Re: State of Iowa Solid Waste Proposed Rule Revisions

Liner Scenarios for EPA Evaluation for the State of Iowa
June 2, 2006

Scenario A

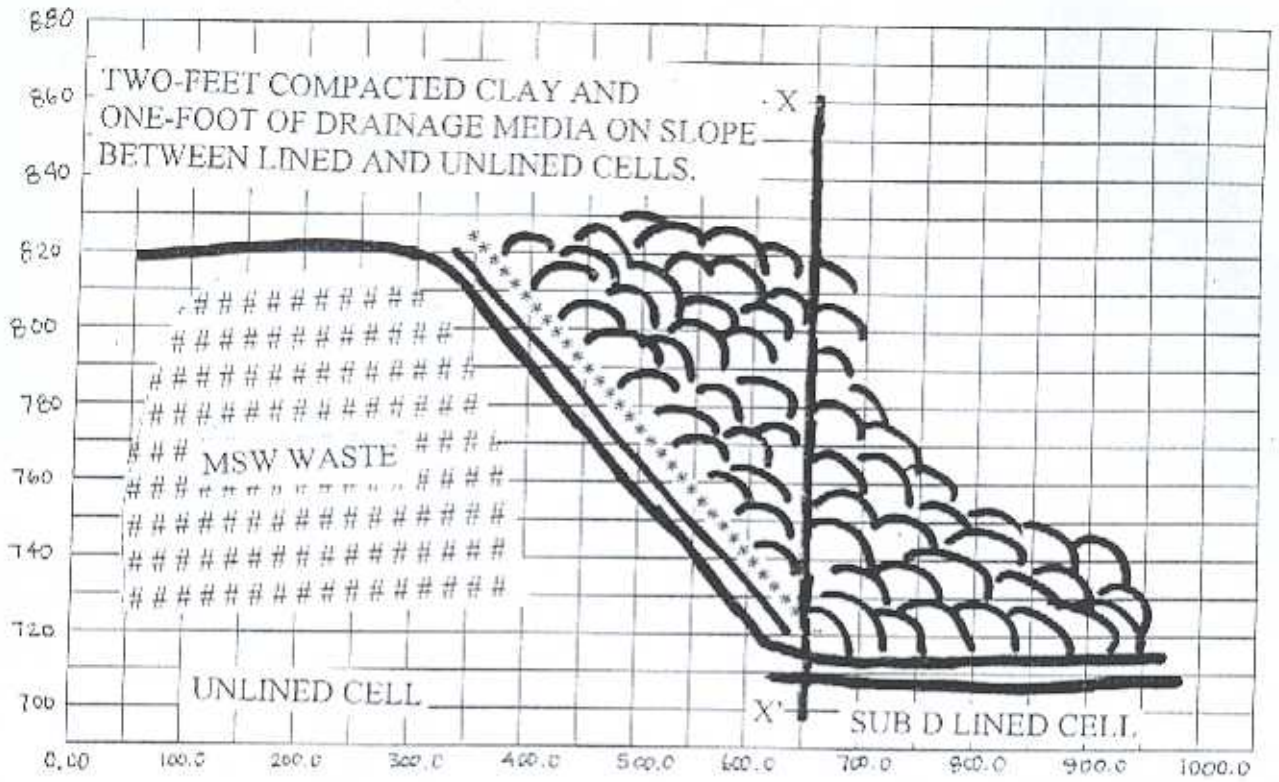
Scenario shows a Sub-D lined cell abutting an existing unlined cell. Two feet of compacted clay and a one-foot equivalent drainage layer was placed prior to placement of waste on the existing slope of the unlined cell. Future waste placement will only occur to the right of the boundary line labeled X-X'. A plan view of this scenario would indicate that future waste placement is occurring only on the lined cell. As such, is this a Sub D compliant site?

Scenario B

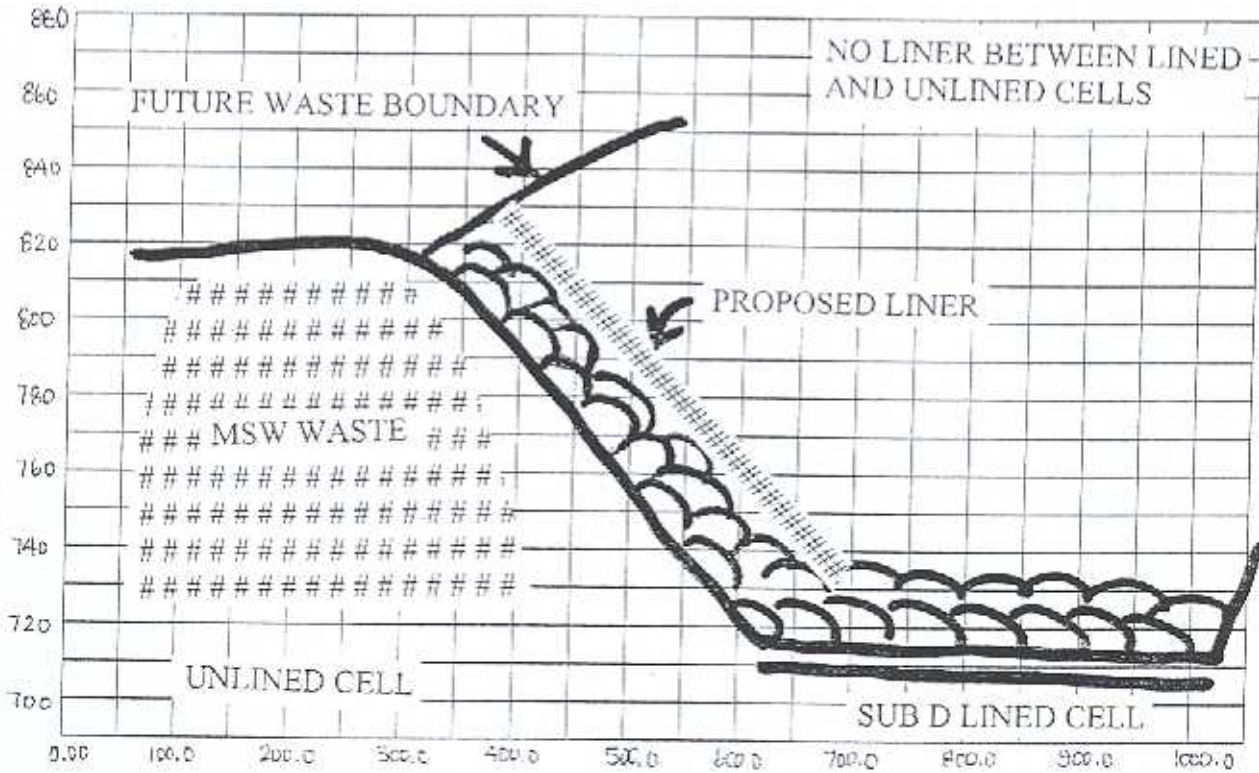
Scenario shows a Sub-D lined cell abutting an existing unlined cell. No barrier layer was placed prior to placement of waste on the existing slope of the unlined cell. A plan view of this scenario would indicate that future waste placement is still occurring over the unlined cell. In addition, the base of the lined cell has had some waste placement as well. As such, if a liner is placed on the existing waste to separate the lined cell from the unlined cell, does the liner have to be tied in at the based of the lined cell? Or can the liner end on top of the waste where the lined cell begins and merely be tied down with additional waste?
